AK C PPCs 48, 49 & 50 – JWS Transport (Technical & Planning) – 2 and 8 November 2021

PRIVATE PLAN CHANGE 48: DRURY CENTRE PRECINCT – KIWI PROPERTY HOLDINGS

JOINT WITNESS STATEMENT (JWS) OF EXPERTS IN RELATION TO TRANSPORT & PLANNING

APPENDIX 1 - JWS TRANSPORT AND PLANNING 2 and 8 November 2021

Figure 1 – Updated Waihoehoe Road interim upgrade cross-section

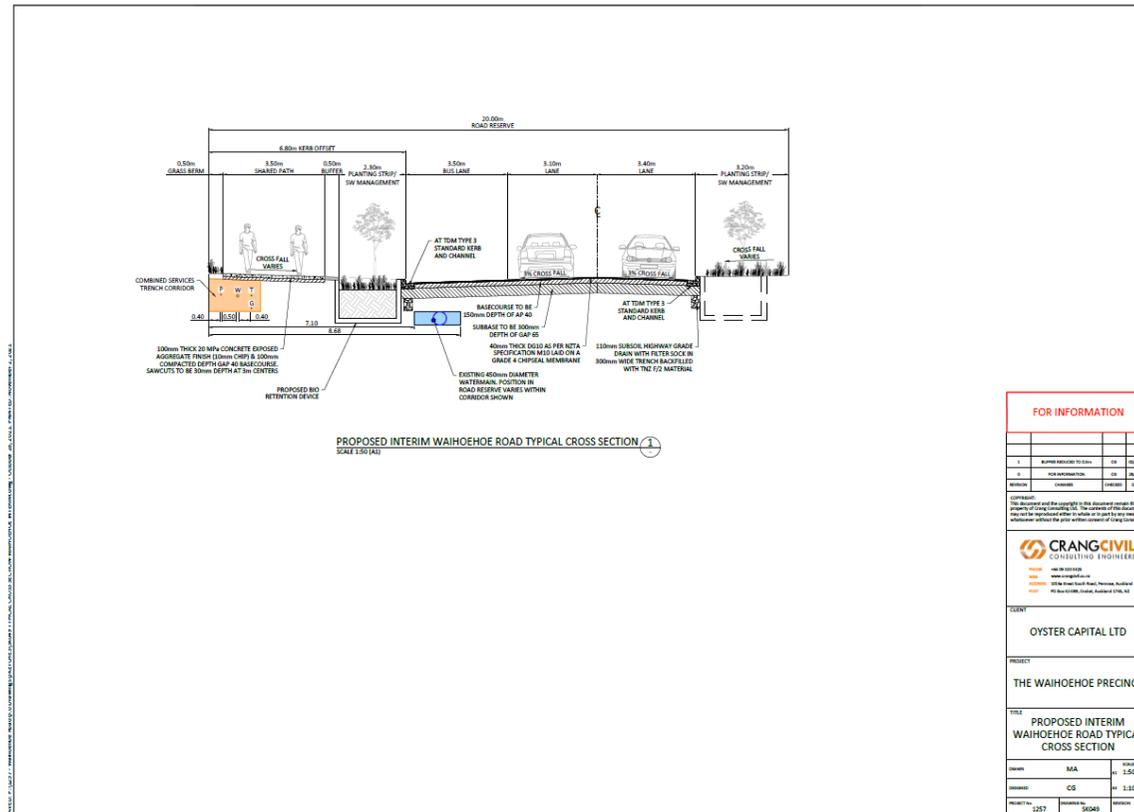
1. Waihoehoe Road interim	Yes (Agree) / No (Disagree)				
	Terry Church on behalf of Auckland Council (as regulator)	Andrew Prosser on behalf of Auckland Transport	Daryl Hughes, Don McKenzie, John Parlane on behalf of Plan Change applicants	Joseph Phillips on behalf of Drury South Limited	Andrew Mein on behalf of Waka Kotahi
<p>Improvement</p> <p>See the updated plan and cross section details in Figure 1 below.</p> <p>Note: the buffer will be reduced from 0.7m to 0.5m.</p> <p>A further version of the plan is being prepared.</p>	<p>Yes, supports the revised mid-block cross section for Waihoehoe Road (interim) in principle on the basis that kerblines and infrastructure are aligned to the current published NOR design on the southern side.</p> <p>Outstanding matter relates to how Waihoehoe bridge is used, being either traffic and active or traffic only on the bridge, with an interim active mode bridge</p>	<p>No, an interim Waihoehoe Road is not supported as AT requires an Ultimate solution to be implemented for Waihoehoe Rd. The interim is likely to need replacement after 4 years (DIFF report) and AT does not support the works replaced in quick succession. This results in poor asset management and fiscal planning.</p>	<p>Yes.</p>	<p>Yes, agree in principle with the revised cross section.</p>	<p>Yes, agree in principle with the revised cross section.</p>

Figure 1: Measurement of outlook space for recessed balconies or terraces

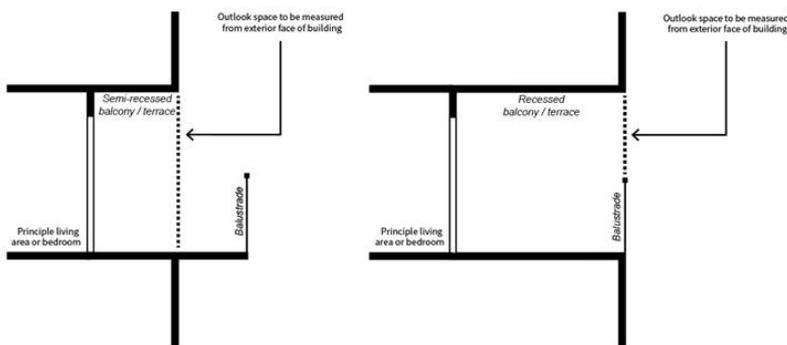
Commented [B&A89]: Auckland Council 22.30

IX.10.1 Drury Centre: Precinct plan 1 – Building Height

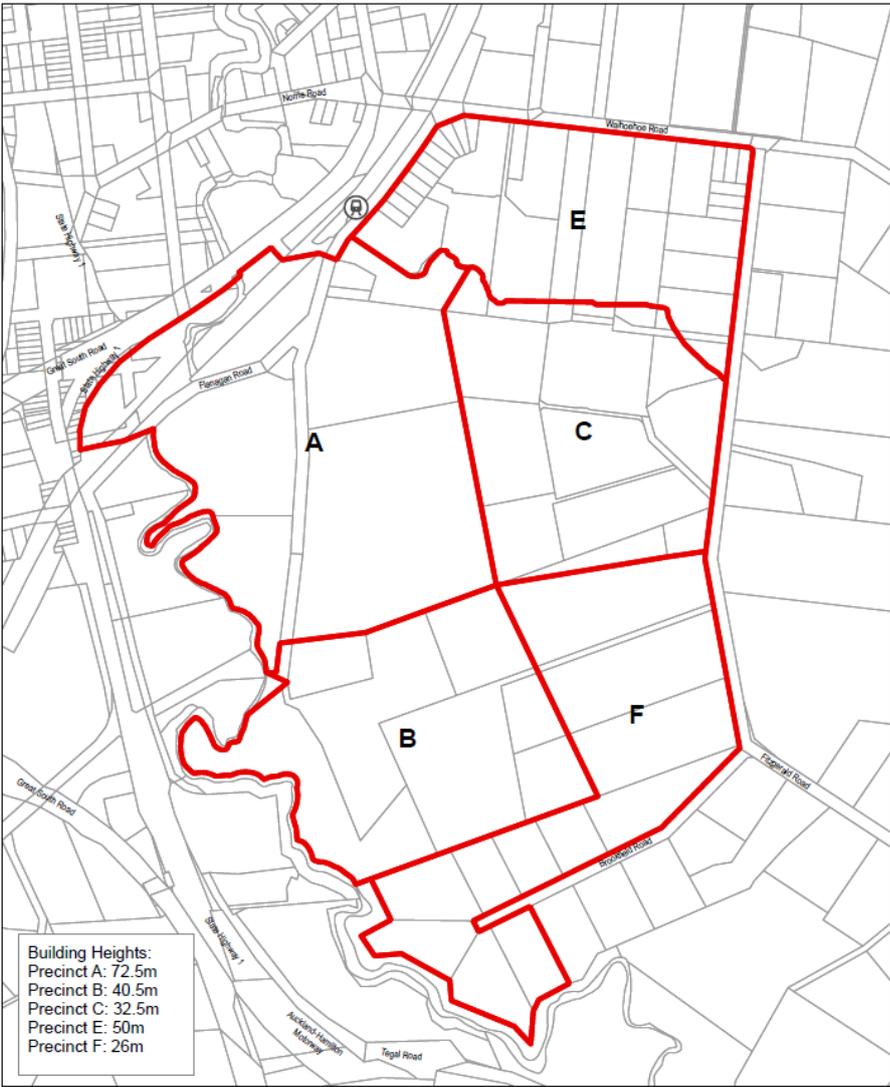
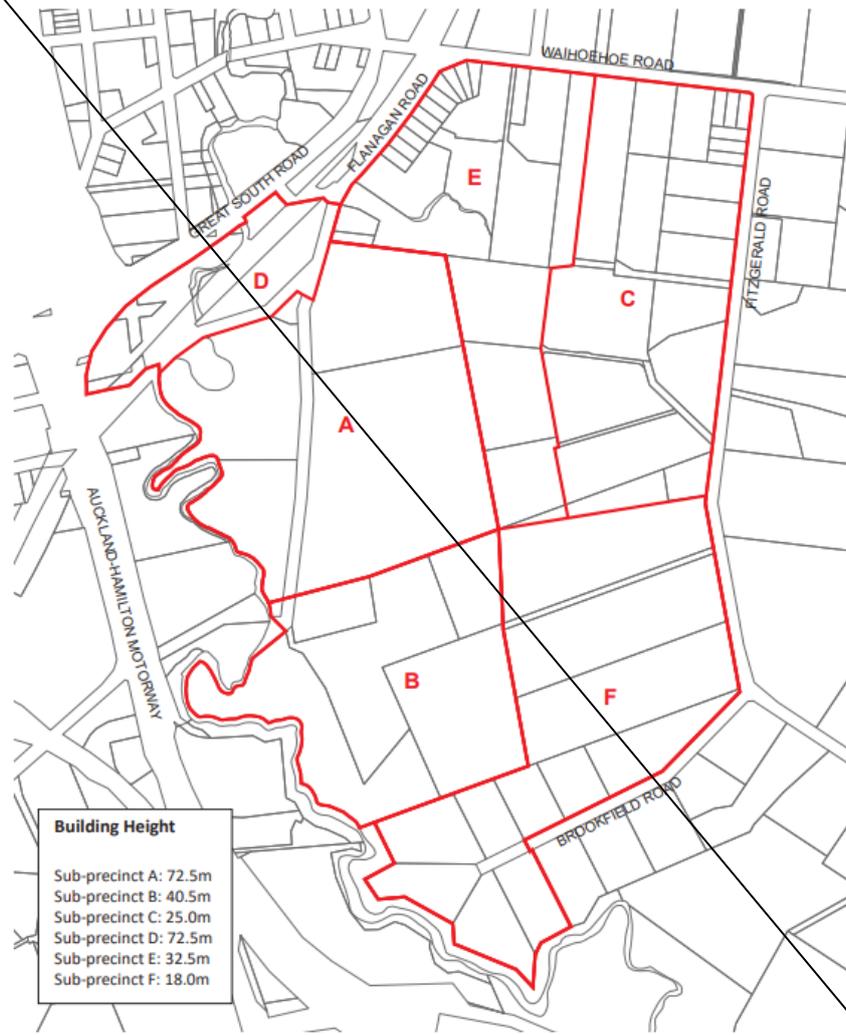
Commented [BA155]: Precinct Plan 1 amended to:
-Remove sub-precinct D and integrate with A (AT 27.44 & KiwiRail 24.5)
-Realign sub-precinct A, C & E boundaries with Maketu Stream
-Increase heights in Sub-precincts E, C & F (Kiwi Property 15.6)
Show revised indicative location of the Drury Central train station (NZTA 23.3, KiwiRail 24.12, Amendments also made in response to s42A recommendations.)

IX.10.2 Drury Centre: Precinct plan 2 – Road Network and Spatial Features

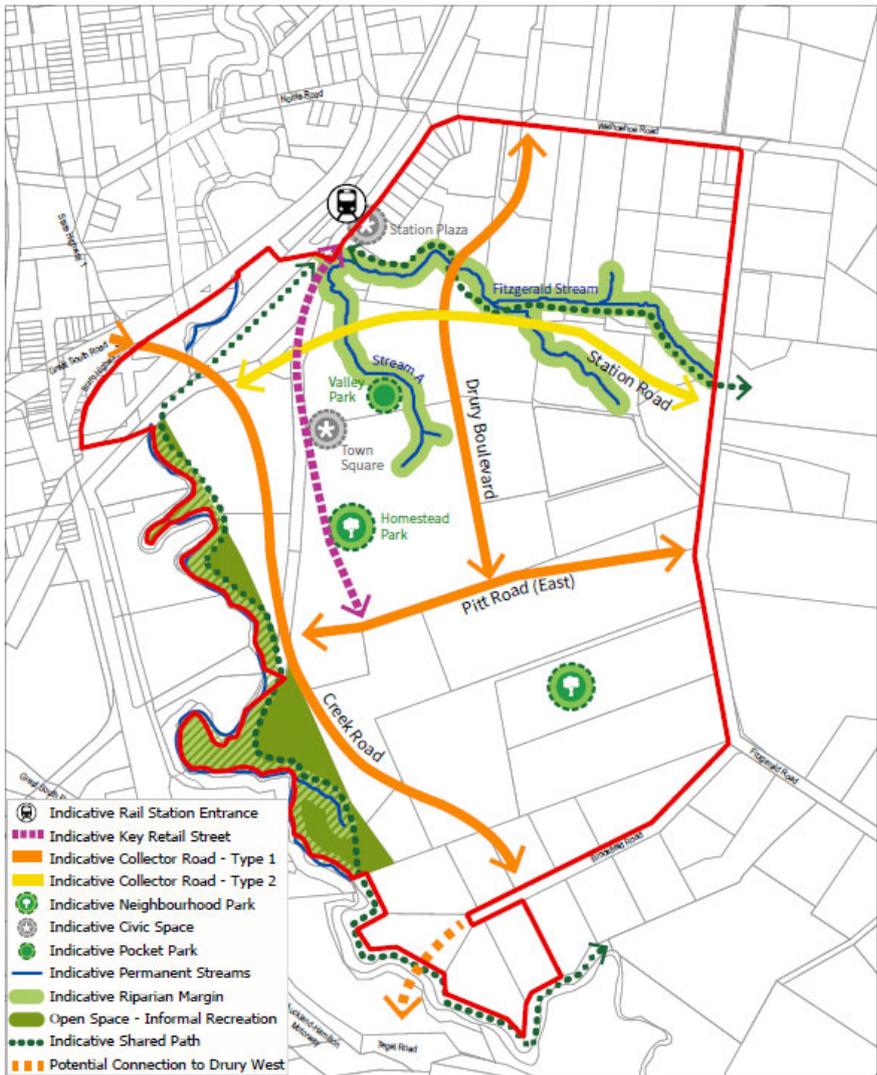
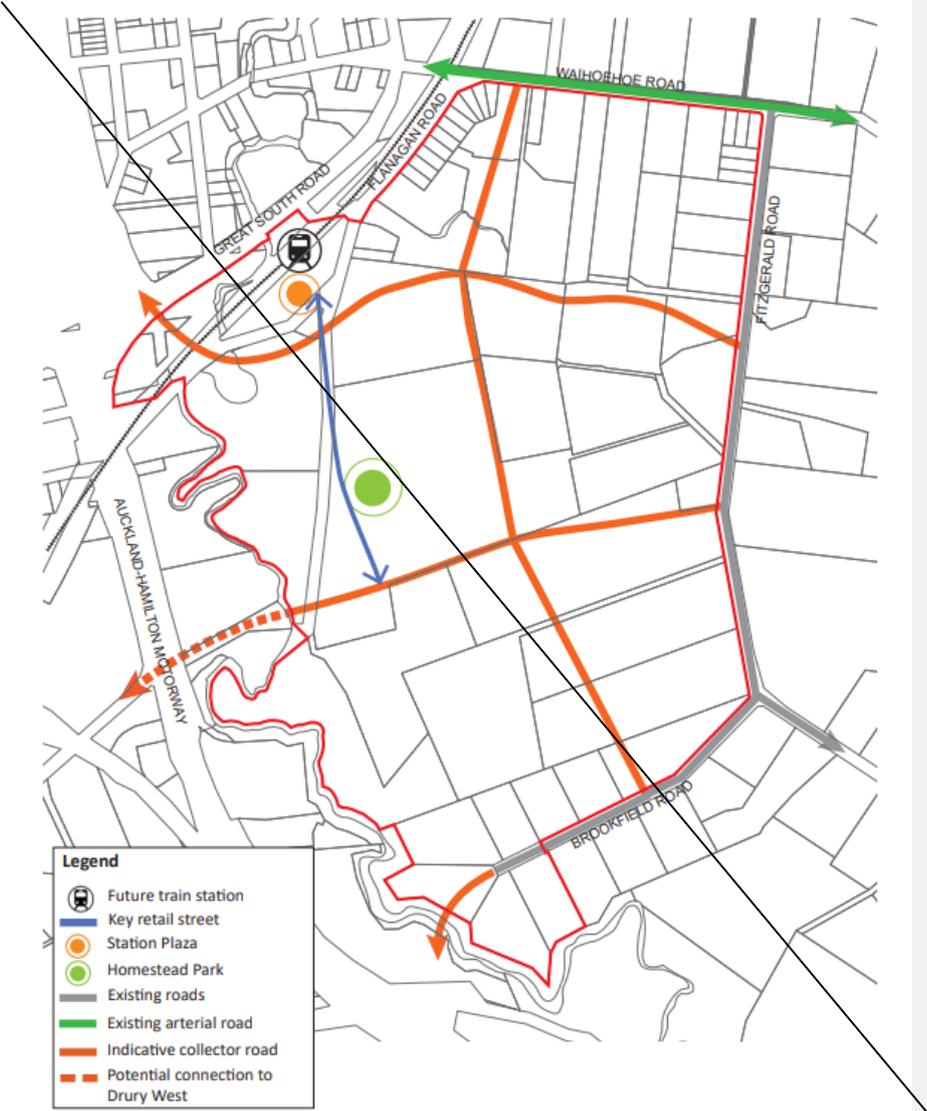
Commented [BA156]: AT.27.43 & NZTA 23.6

Precinct Plan 2 amended to:

- Revise the location of the collector roads to align with the Drury Centre Masterplan
- Show revised indicative location of the Drury Central train station
- Revise the location of the Key Retail Street to integrate with the Drury Central train station
- Show the indicative open space network, including shared paths
- Show a different collector road status for Station Road.
- Show the Brookfield Road/Quarry Road link as a "potential connection"**

IX.10.2(2) Drury Centre: Precinct plan 2A – Road Network and Key Retail and General Commercial Frontage controls

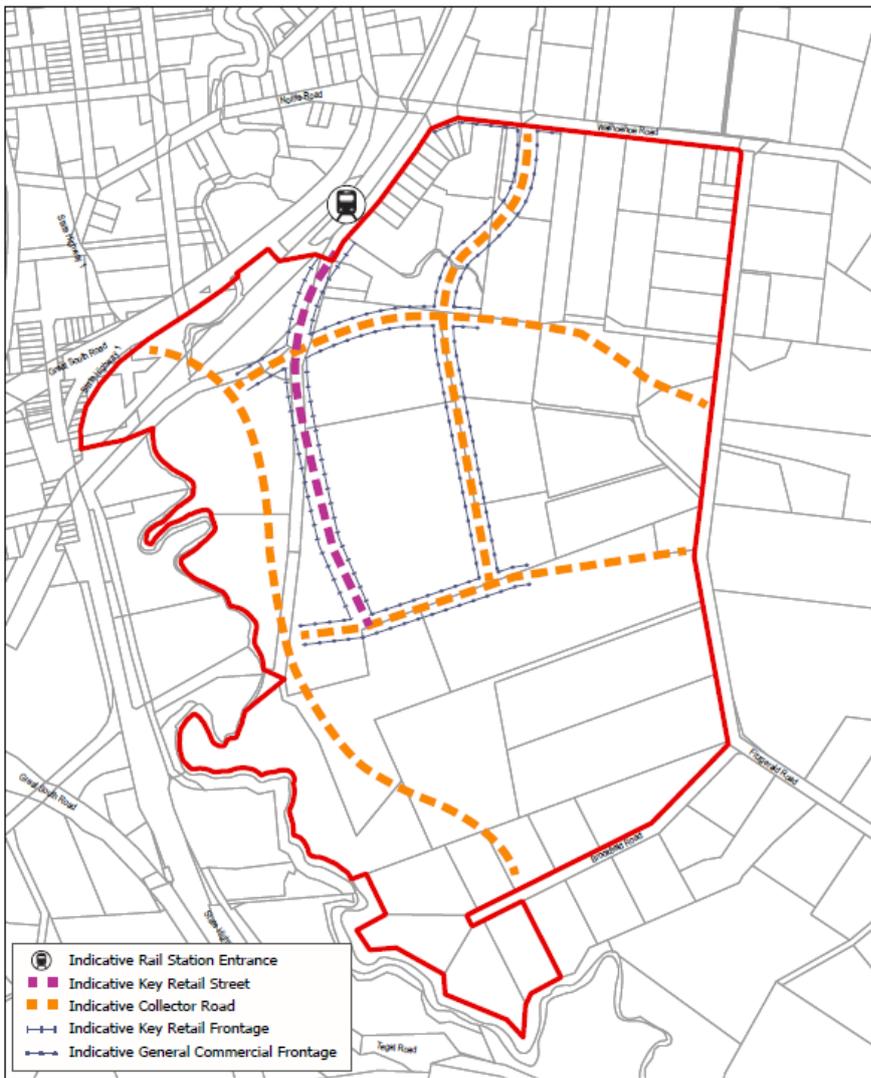
Amendments made in response to s42A recommendations.

Further amendments made in response to the evidence of Christopher Turbott for Auckland Council:
- "indicative" added to Key Retail and General Commercial Frontage

Additional wording to state that the frontage controls apply to sites adjoining the final location of the Collector Roads.

IX.10.3 Drury Centre: Precinct plan 3 – Transport Staging Boundary

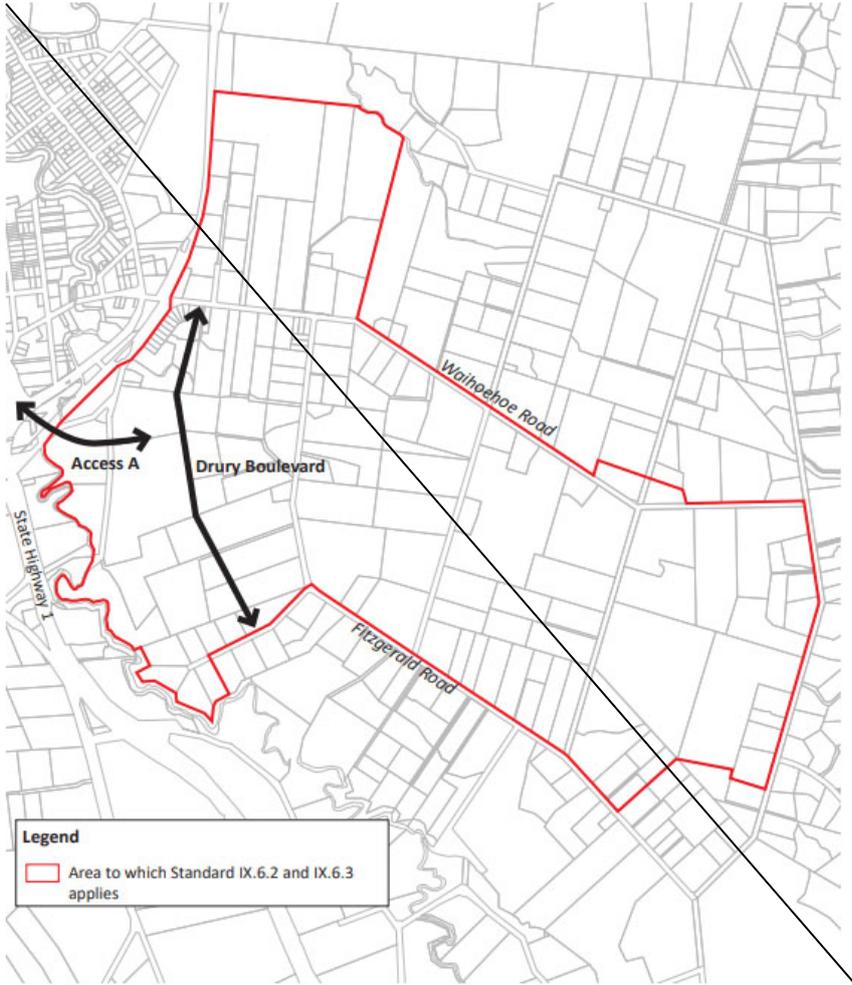
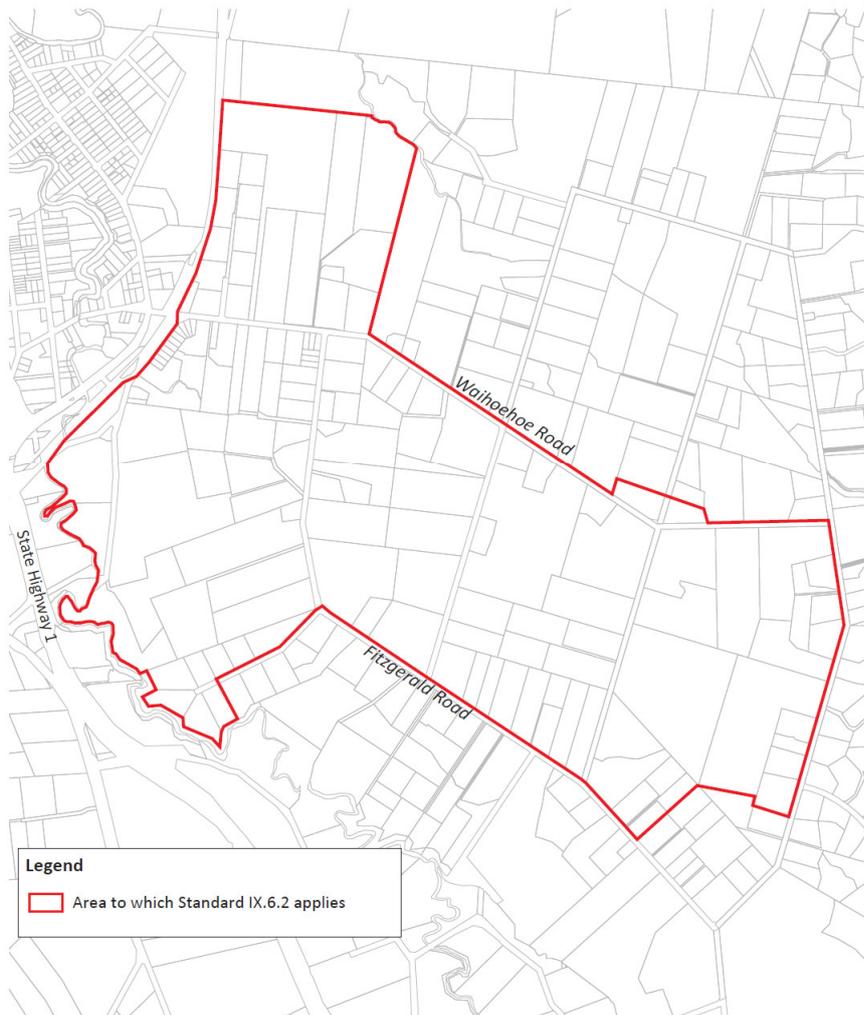
Commented [B&A158]: Consequential amendments to update Precinct Plan 3 to align with new transport trigger provisions.

Commented [B&A159]: Update this plan to show the upgrades referred to in the permitted standards

(1) Waihoehoe Road (west of Fitzgerald Road)

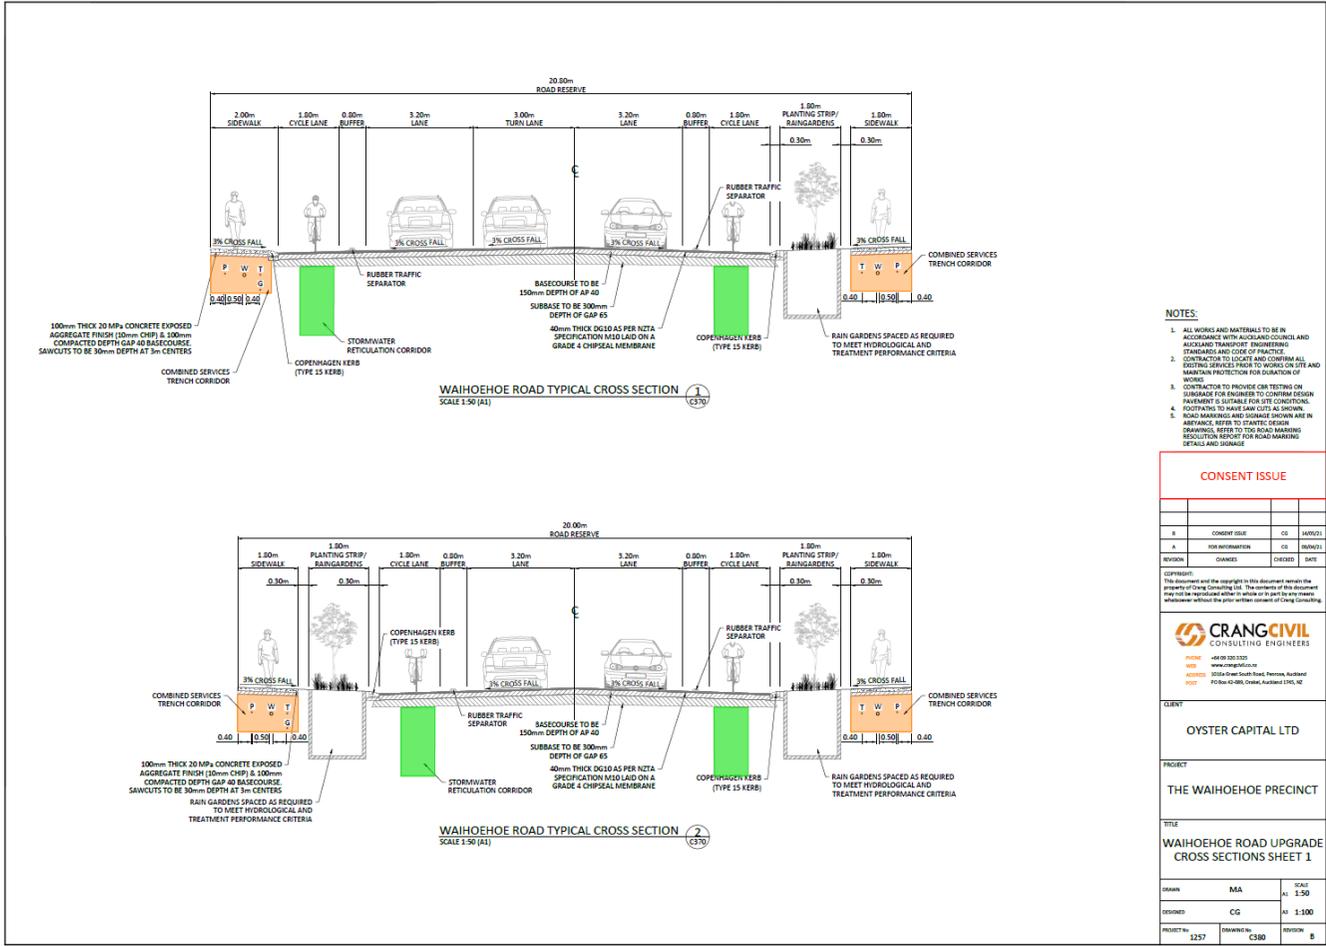
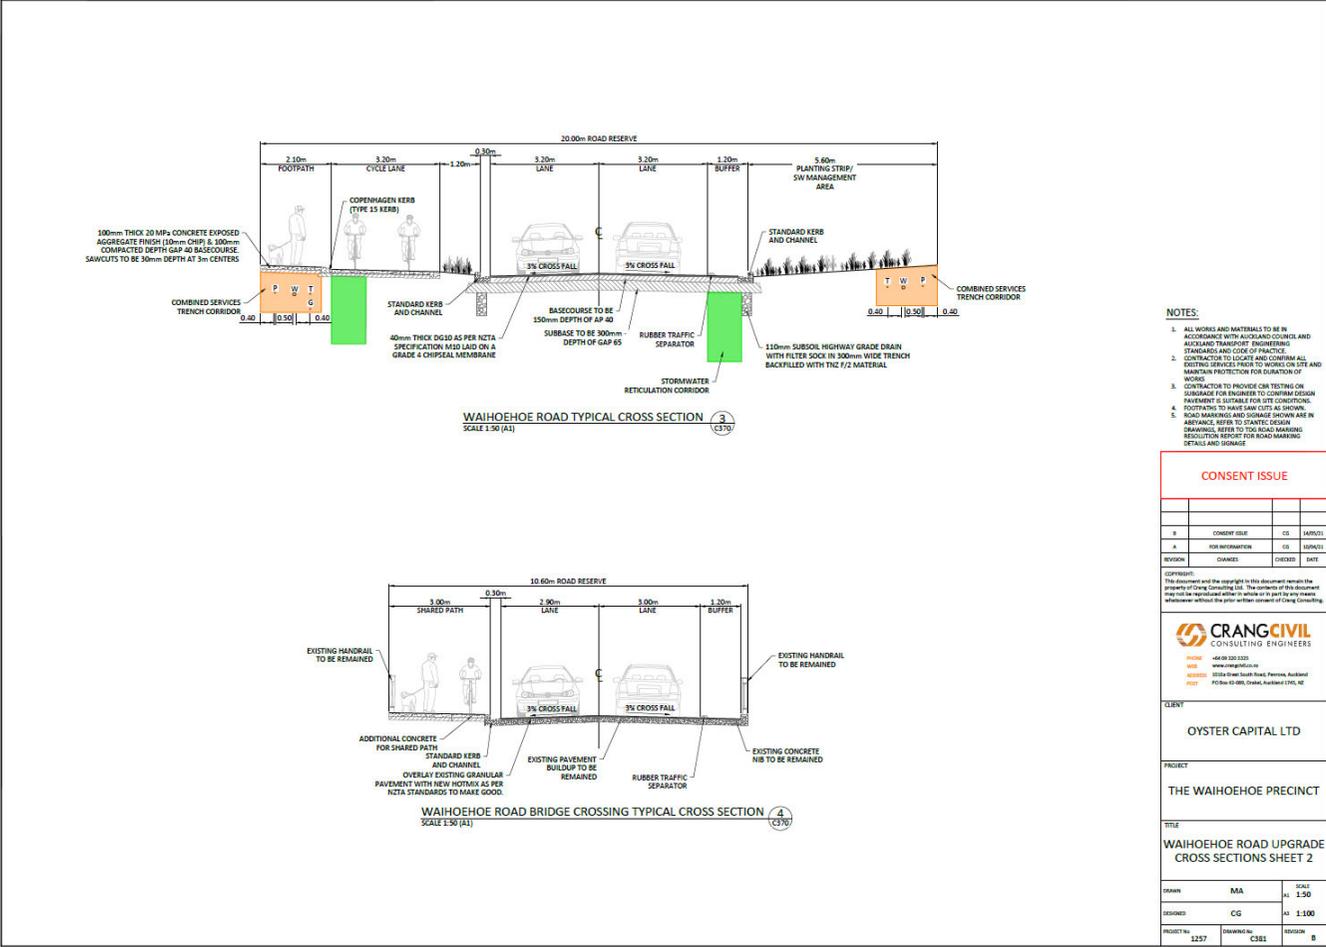
Commented [B&A167]: To be revised
